APPENDIX I

Written Comments on the DEIS,
Community Board 5 and Manhattan Borough
President's Recommendations,
and Vornado Correspondence

15 Penn Plaza: CPC public hearing questions (5/26/2010)

15 Penn Plaza: Response to CPC Questions
(CPC Public Hearing: 5/26/2010)

ATTACHMENT 4

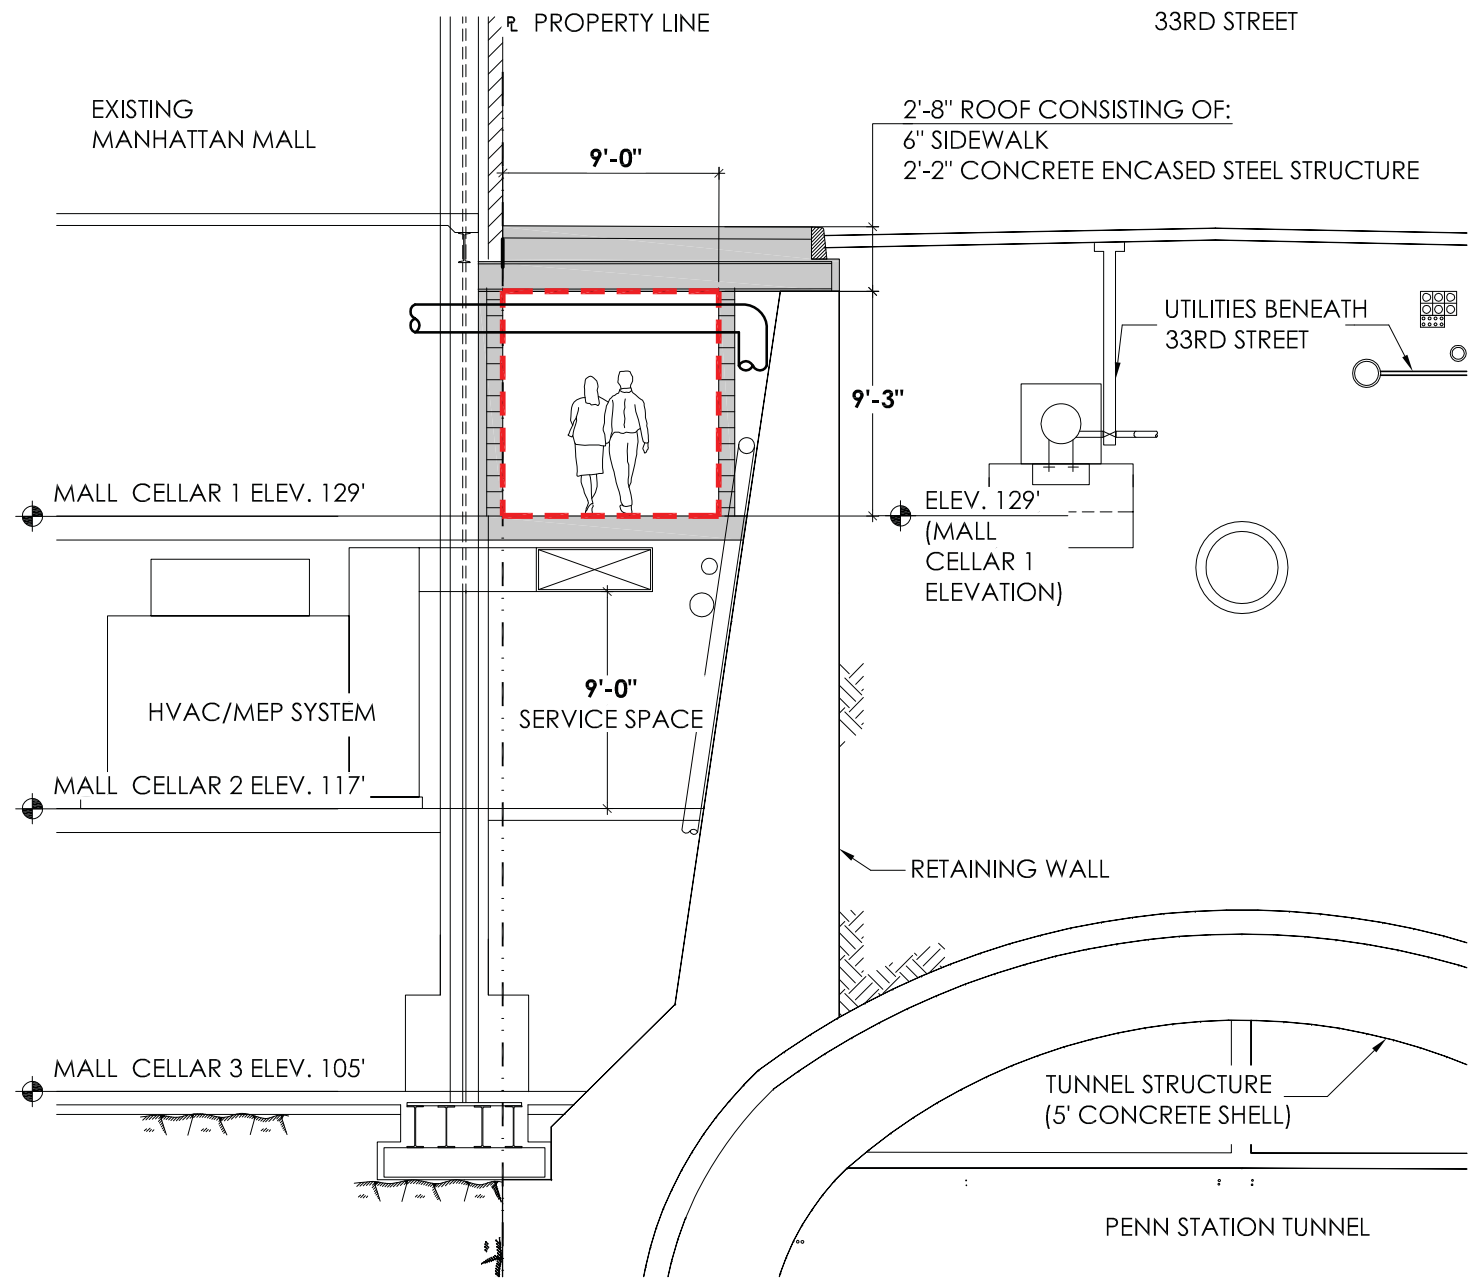
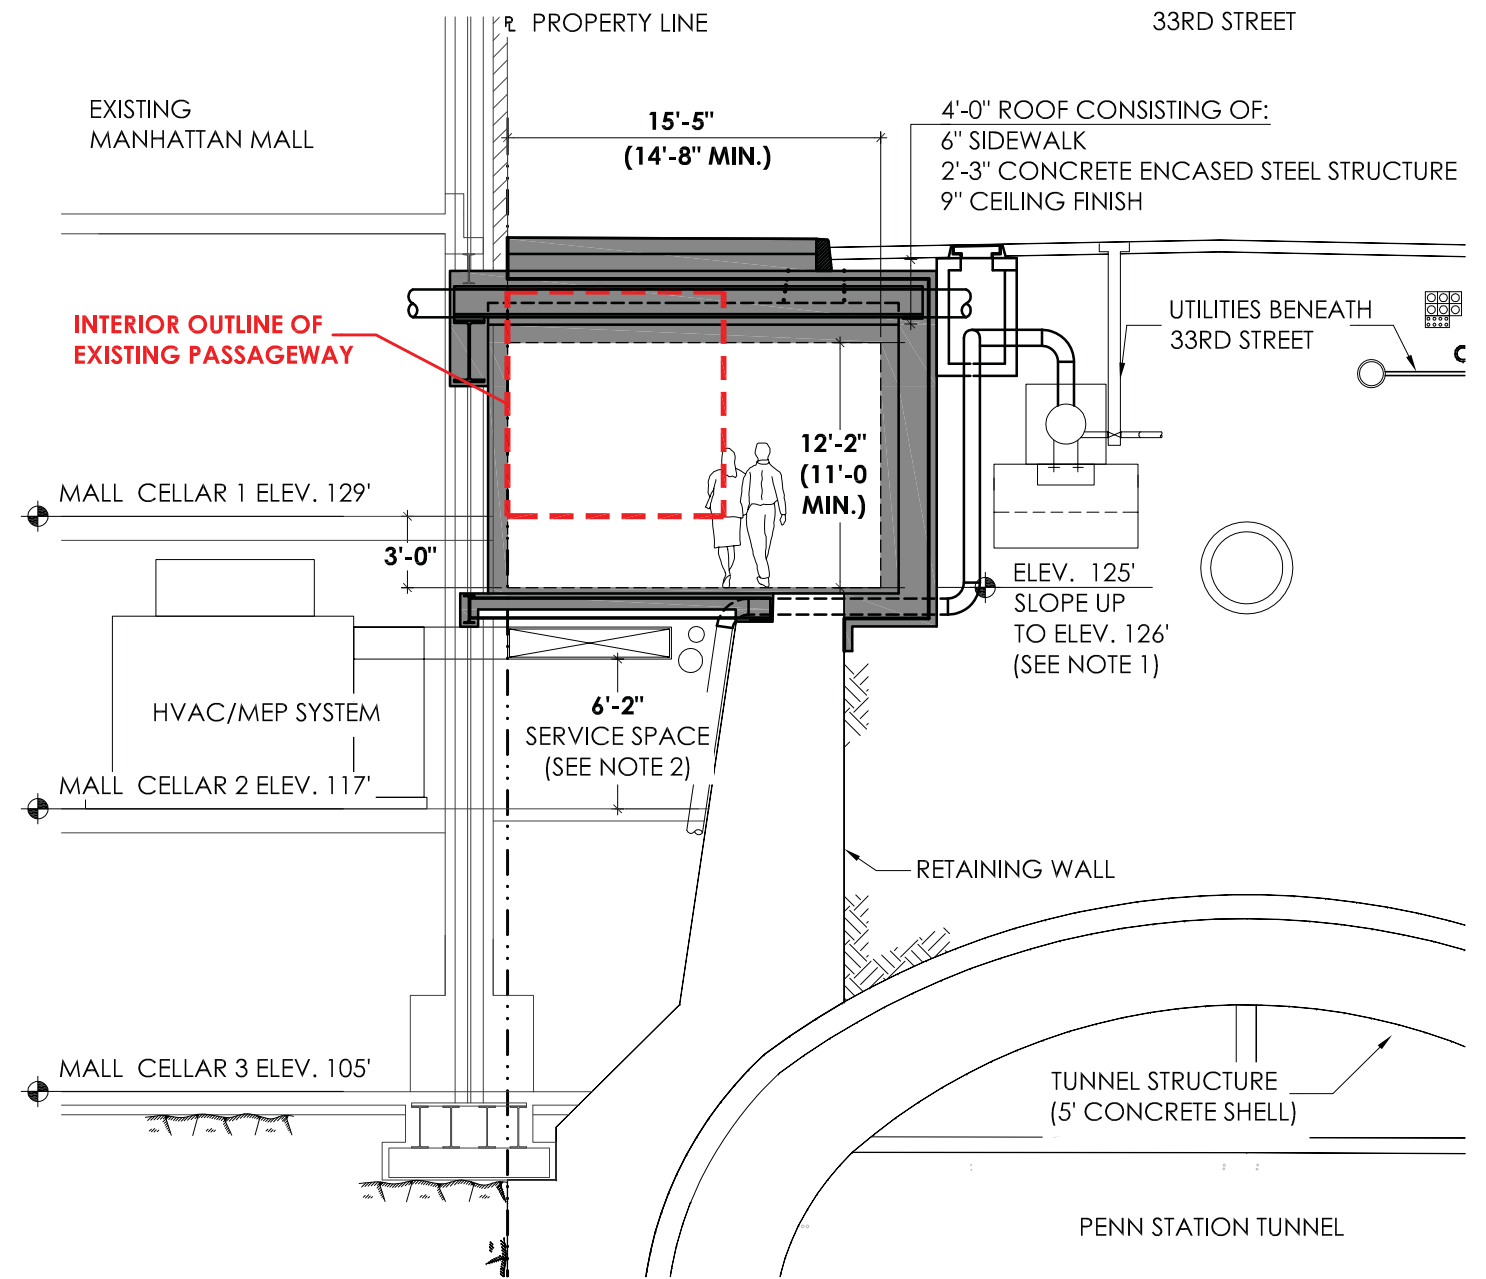
As requested, a plan of the passageway is provided in Attachment 1. Elevations detailing the north wall and south wall are shown in Attachment 2. Attachments 3 and 4 are sections showing the existing and proposed configuration of the passageway at both 15 Penn and the Manhattan Mall respectively.

1. ELEVATION DICTATED BY 6TH AVENUE & 33RD STREET ENTRANCE TO ACCOMODATE ESCALATOR RUN AND MINIMUM RESERVOIR SPACE
2. A MINIMUM HEADROOM IS REQUIRED WITHIN THE MALL CELLAR 2 BELOW THE PASSAGEWAY TO ACCOMODATE BUILDING HVAC/MEP SYSTEMS AND TO MAINTAIN SERVICE ACCESS

3 PARTIAL REFLECTED CEILING PLAN
SCALE: 1/4"=1'

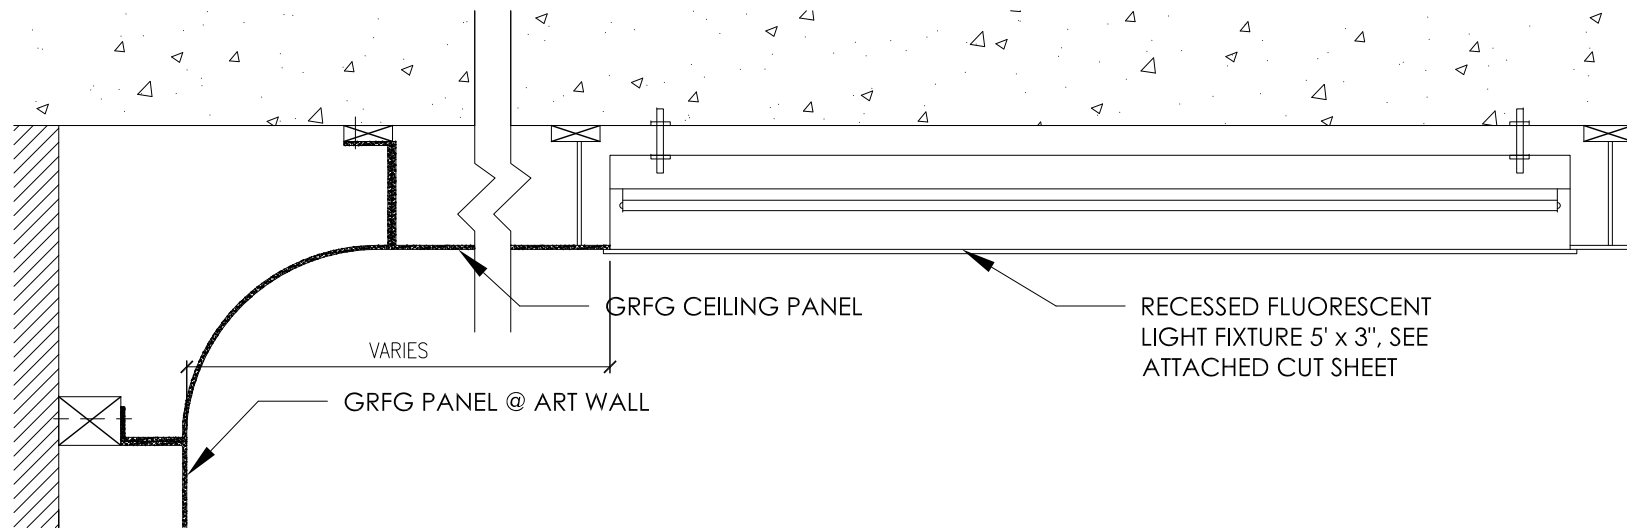
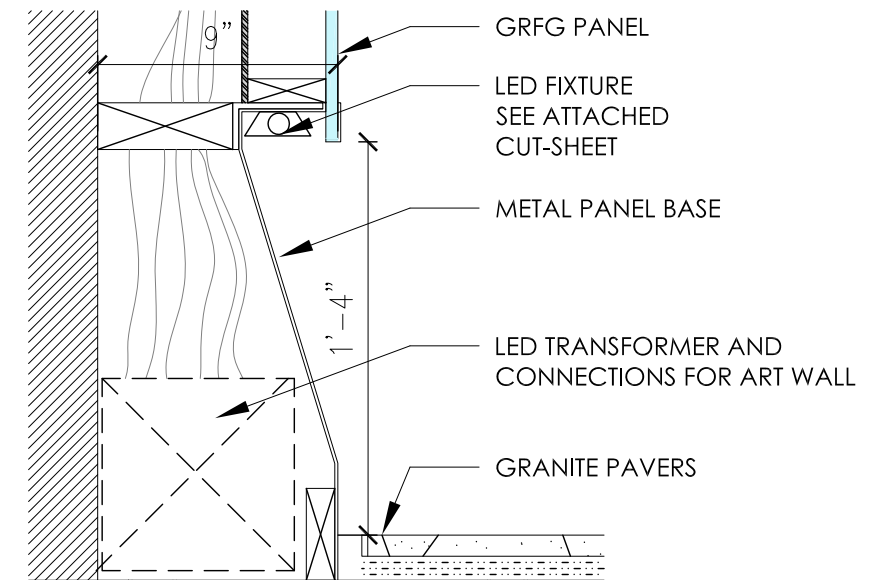
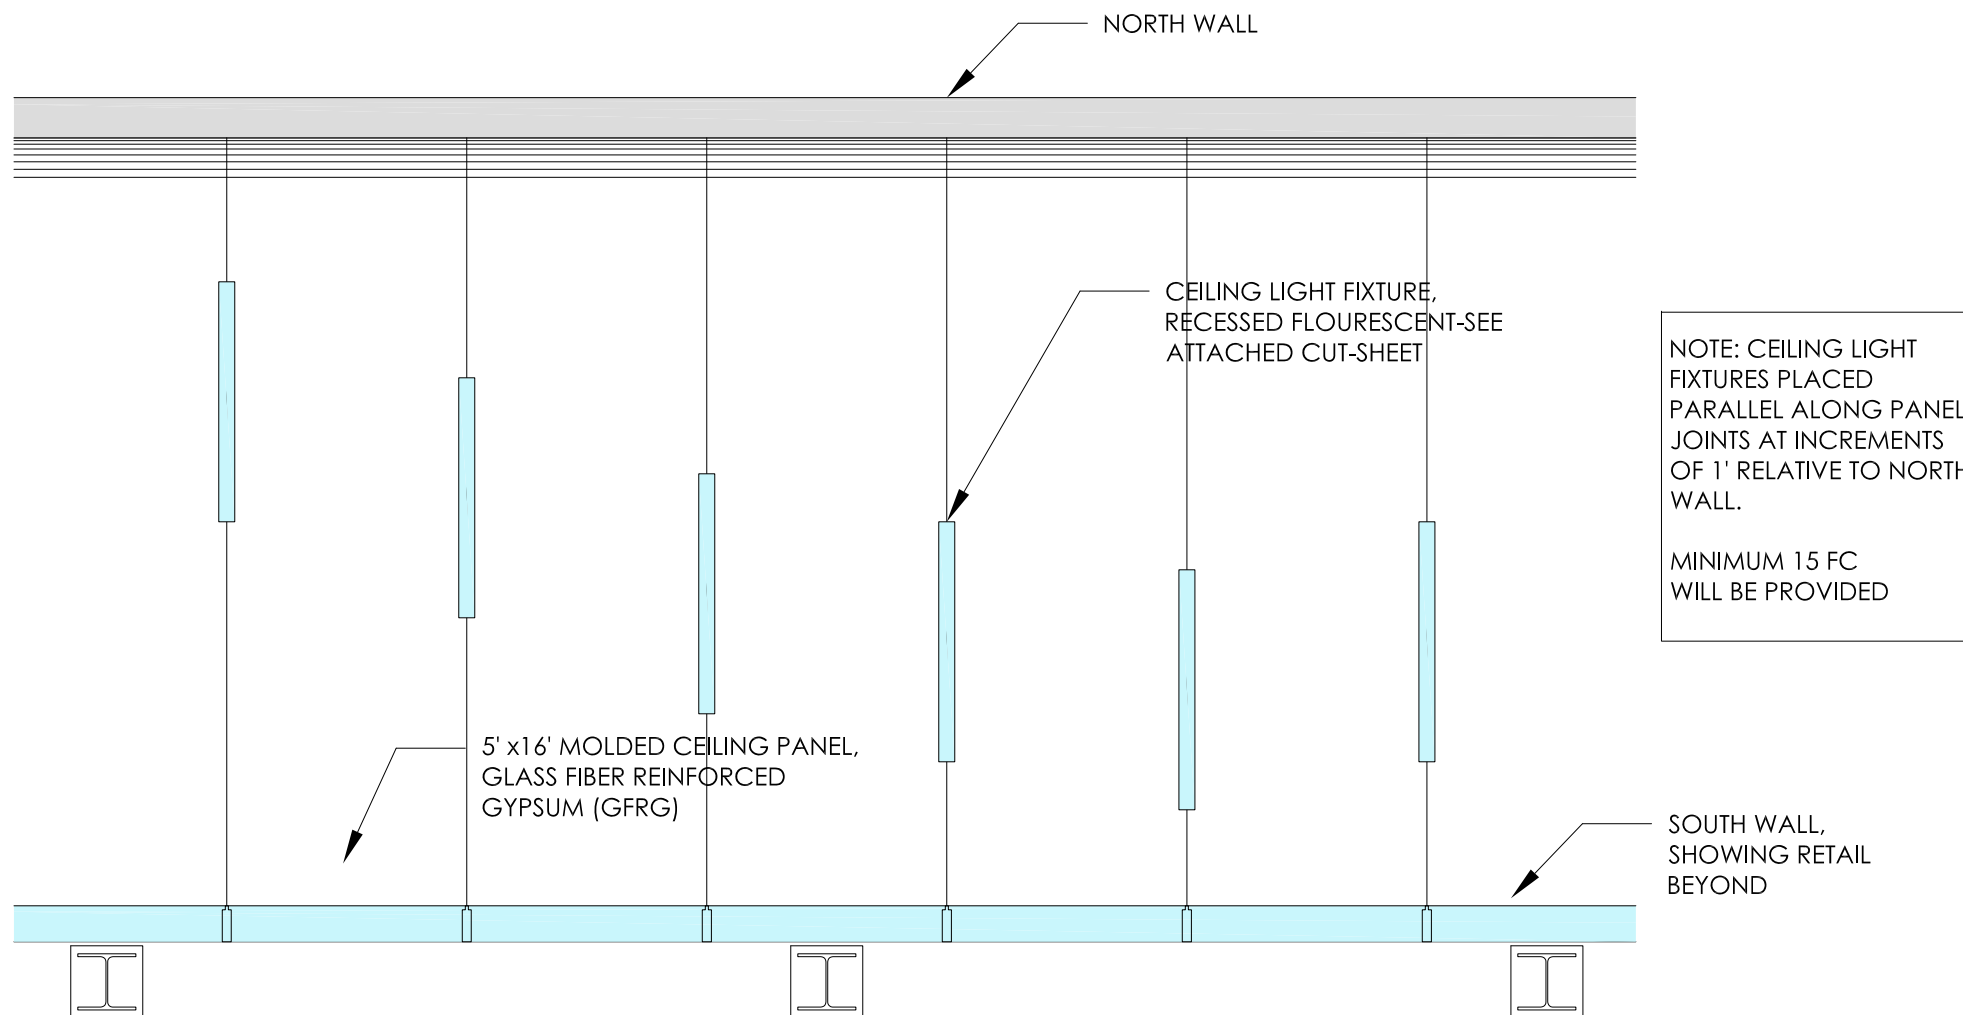
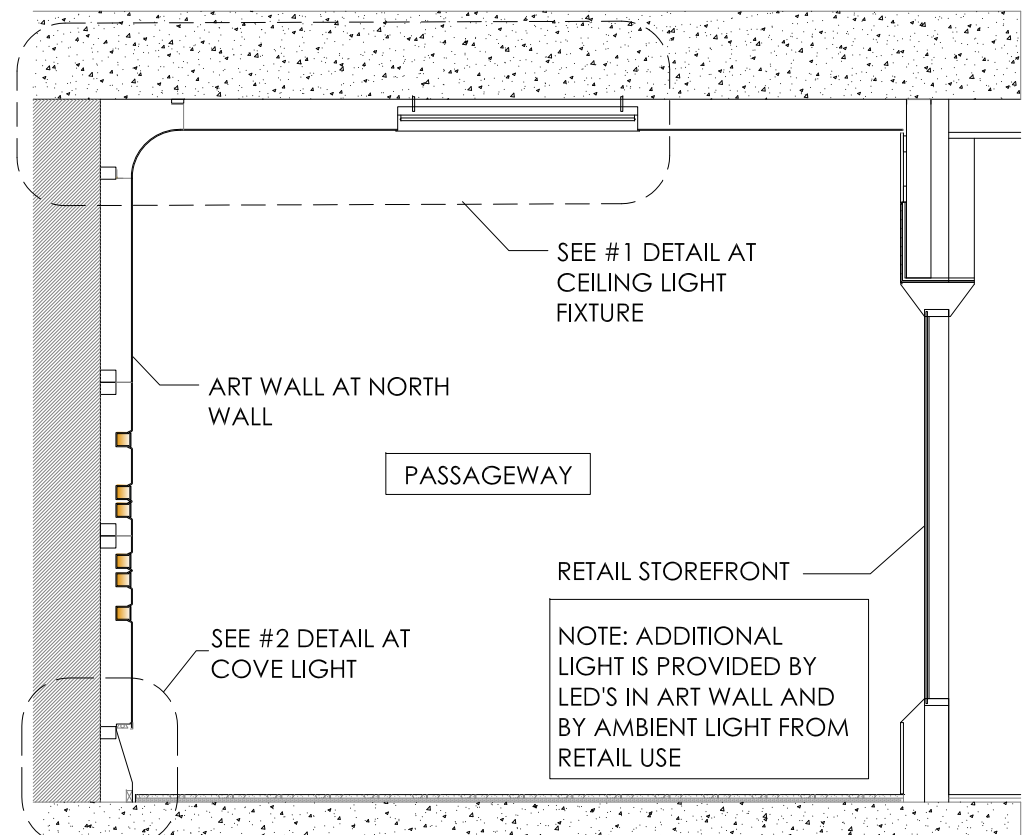
Lighting plan

Attachments 5 and 6 contain a reflected ceiling plan, identifying lighting within the passageway.

NORTH ELEVATION

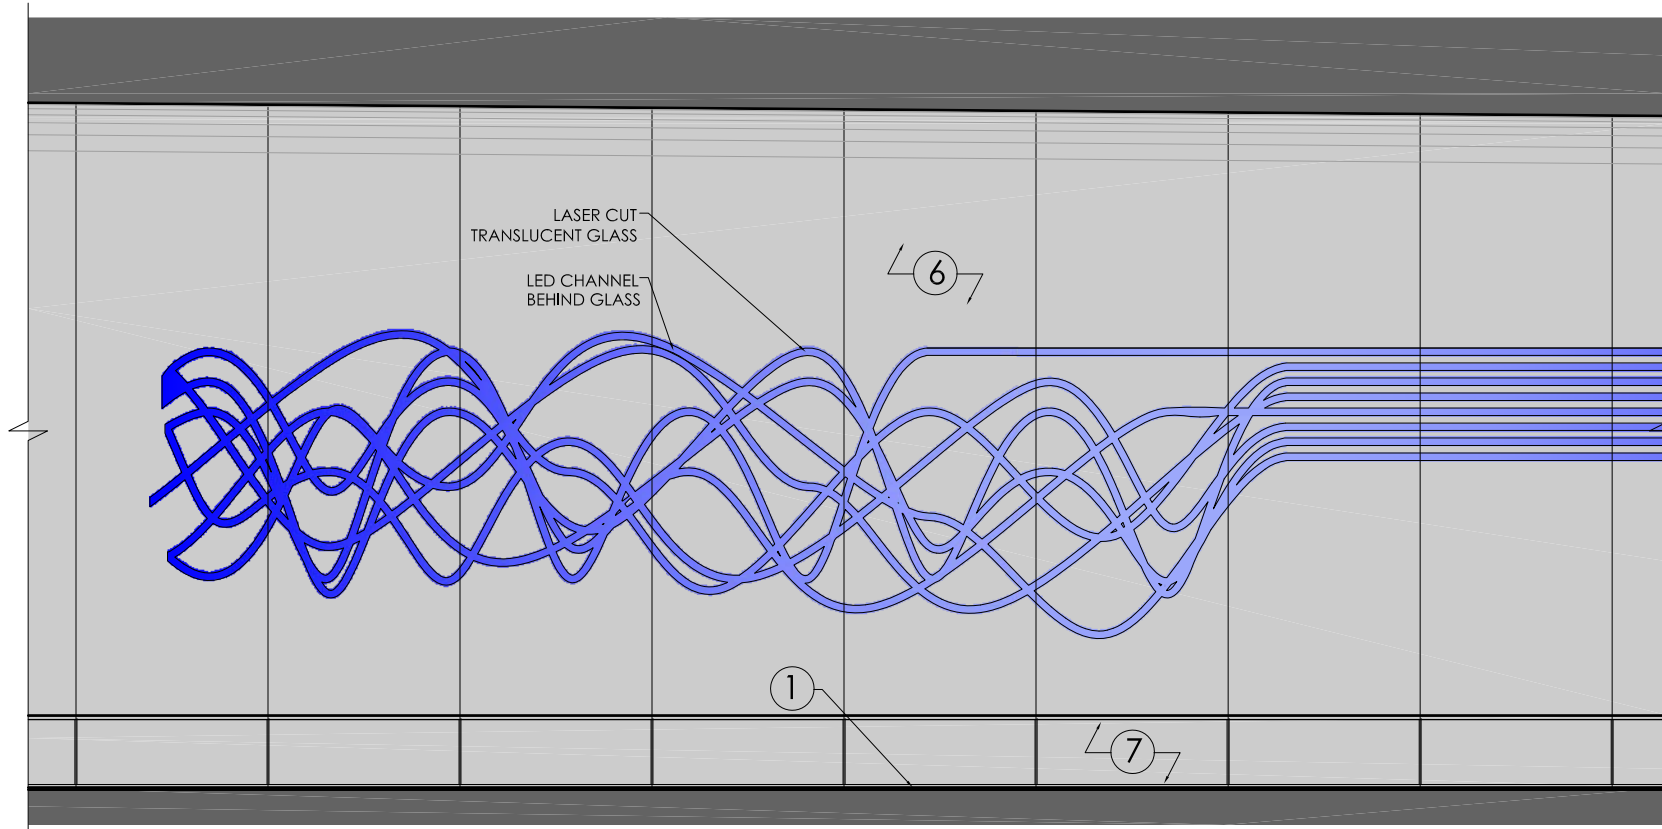
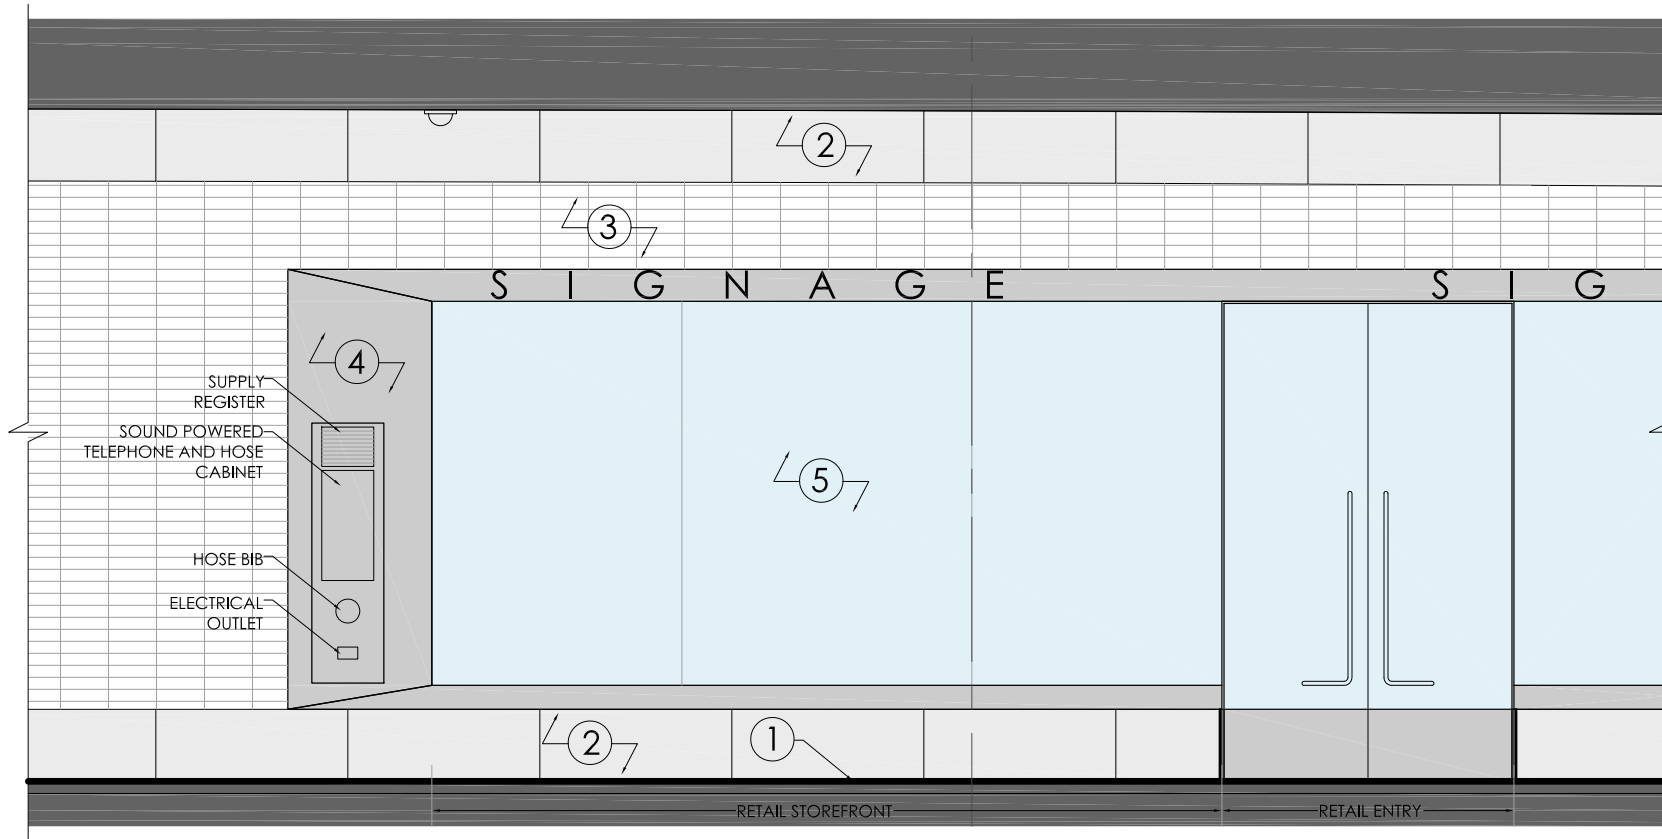
10. A question was raised about the potential activation of the south wall of the passageway along the Manhattan Mall portion.

- Approximately 330 linear feet of passageway run alongside the 15 Penn site.
- The north wall of this section of the passageway will be activated by LED art installed as indicated on the elevation plans.

- The north wall of this section of the passageway will, similar to the 15 Penn section, be activated by LED artwork installed as indicated on the elevation plans.
